## RE: Application for Waste Licence Ref. No. W0241-01Greenstar Ltd., Clavass, Eniscorthy, County Wexford

Re: Proposed Greenstar facility at Enniscorthy, Co. Wexford.

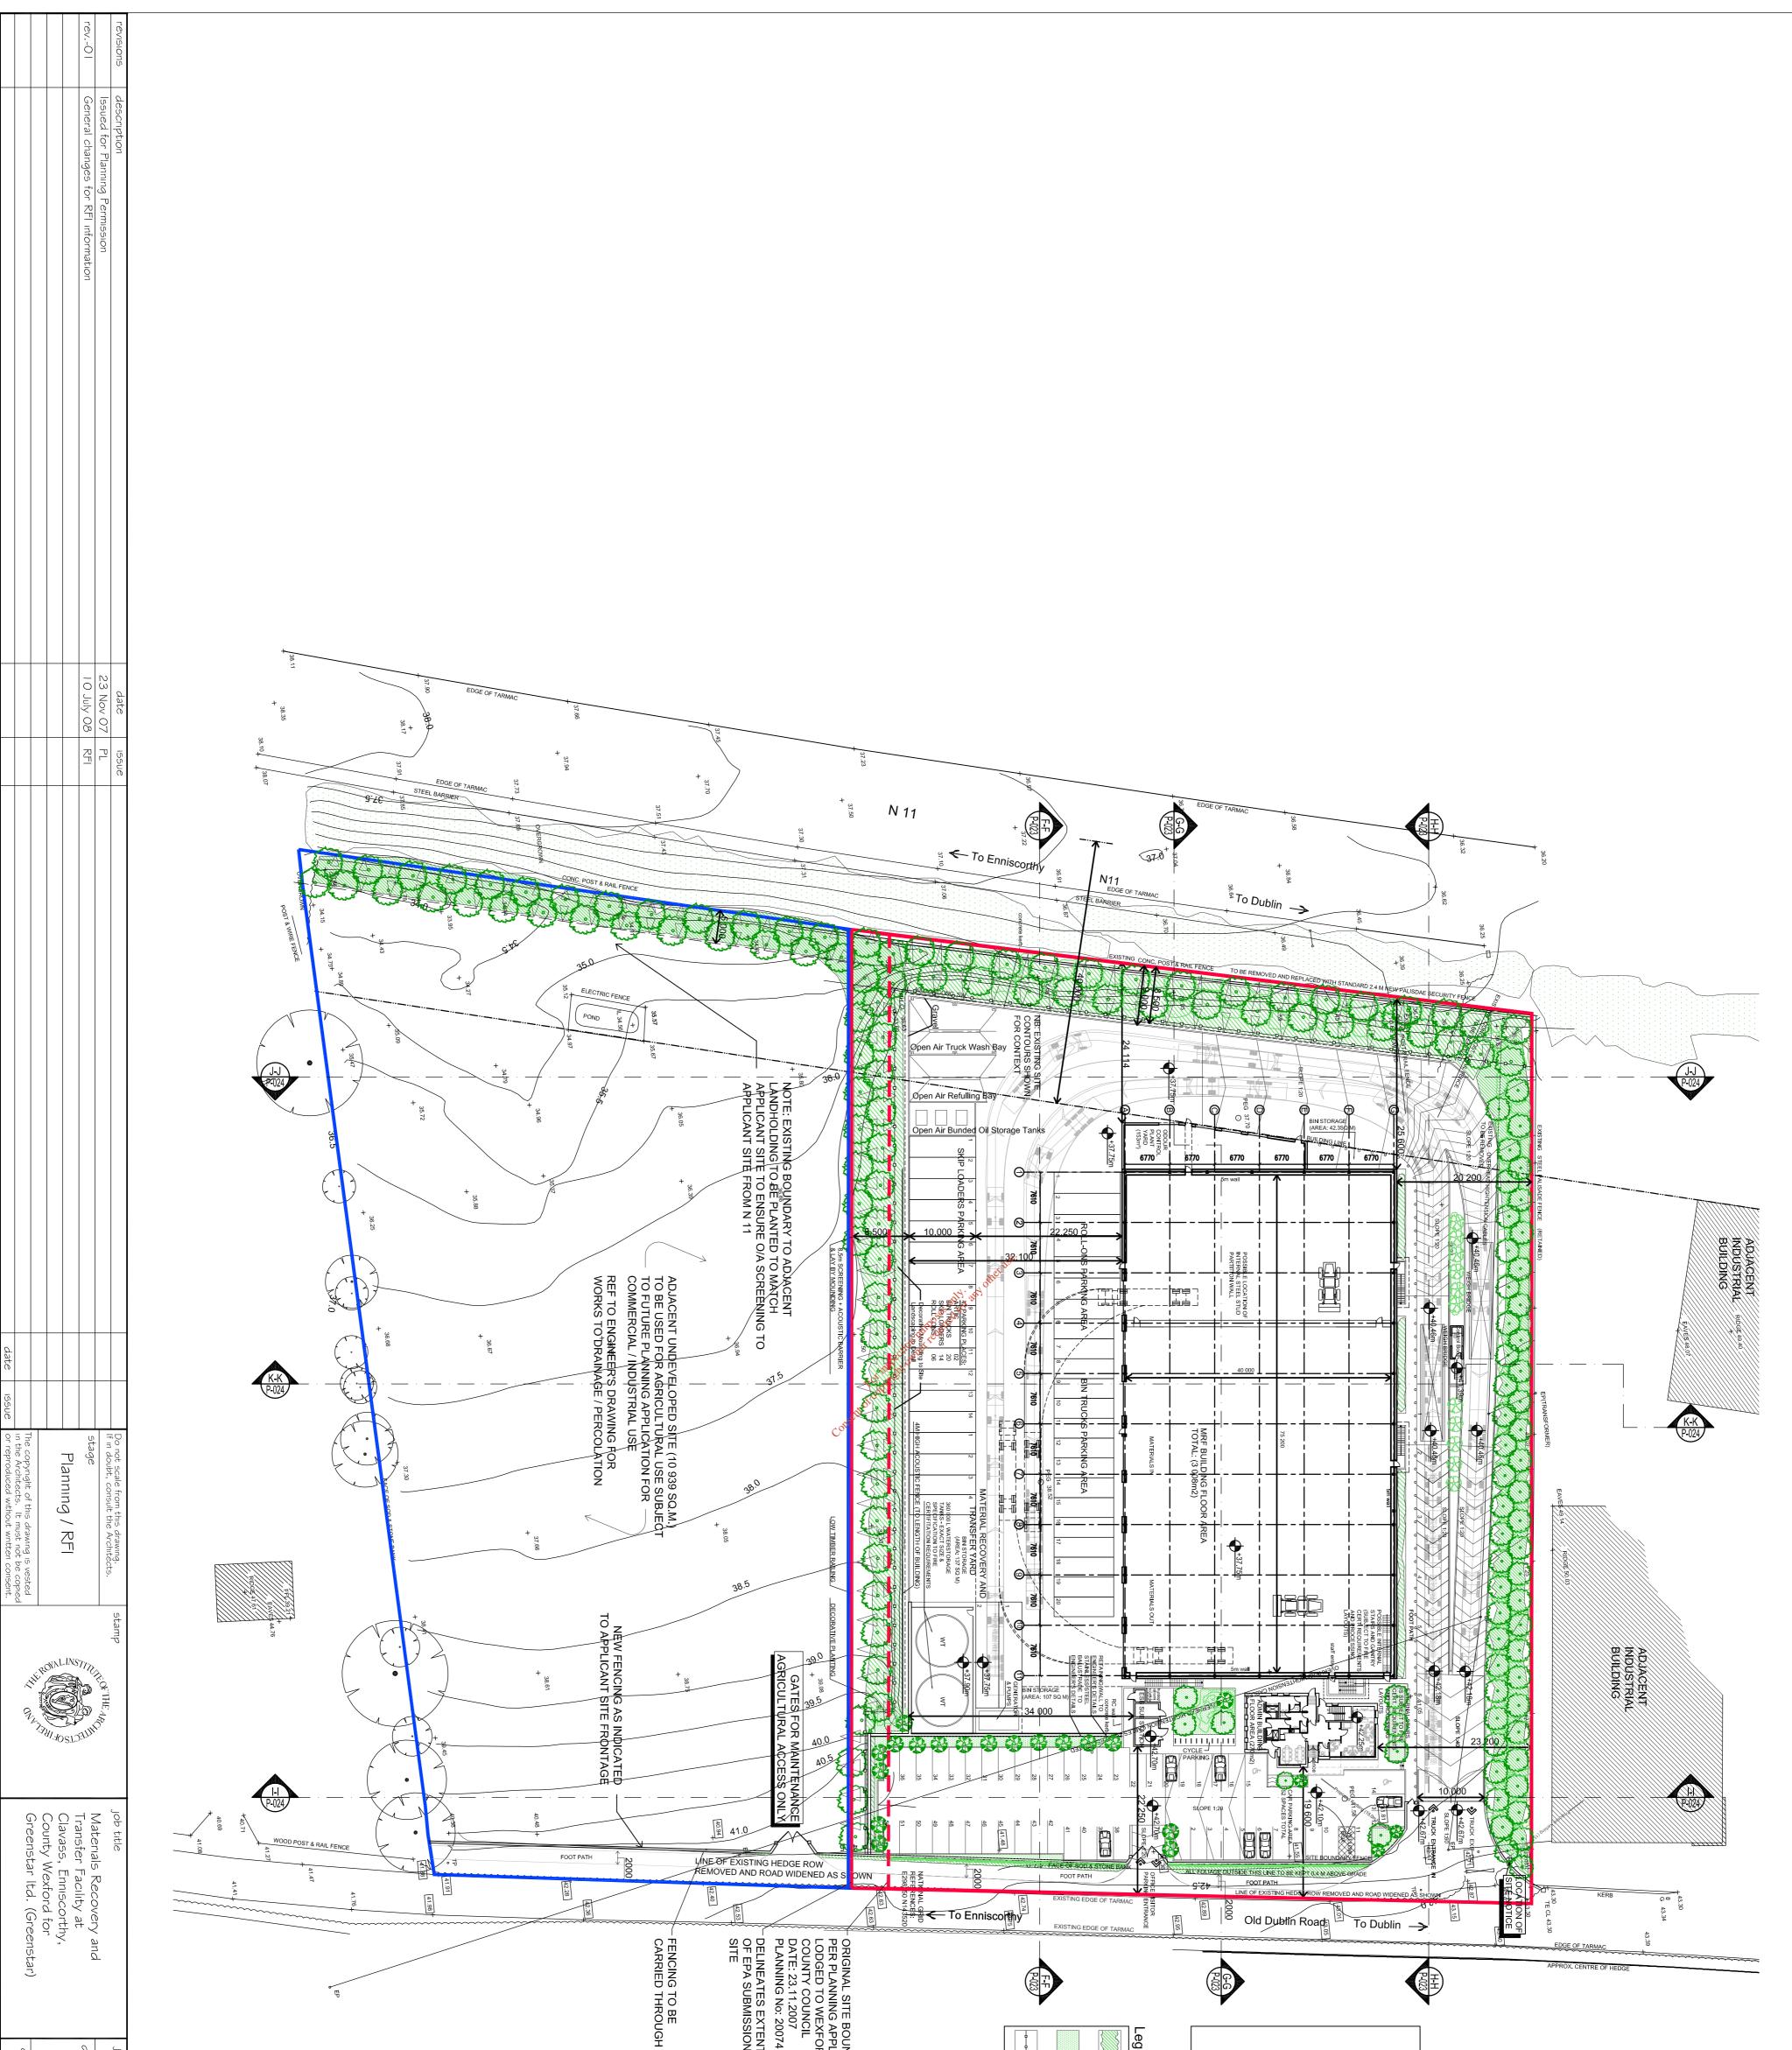
Is. Furlong, On behalf of Greenstar Ltd., I enclose and drawing showing the revised site layout. The revision to the southern site boundary and internal layout was required in response to queries from the planning authority. The southern boundary has moved approximately 5m to the south of the original line. The acoustic barrier has also moved to the south.

ther use. I wish to confirm that I have received and reviewed drawing 1375-R-003 Rev-1 dated 10.04.08. The drawing shows a proposed relocation of the southern boundary of the site wis now proposed to locate this boundary 3 m south of the original southern boundary. The proposed acoustic barrier will also be relocated. tion

I wish to confirm that the proposed relocation will not affect offsite propagation of noise emissions. A relocation of at least 20 m would be required before any change would arise.
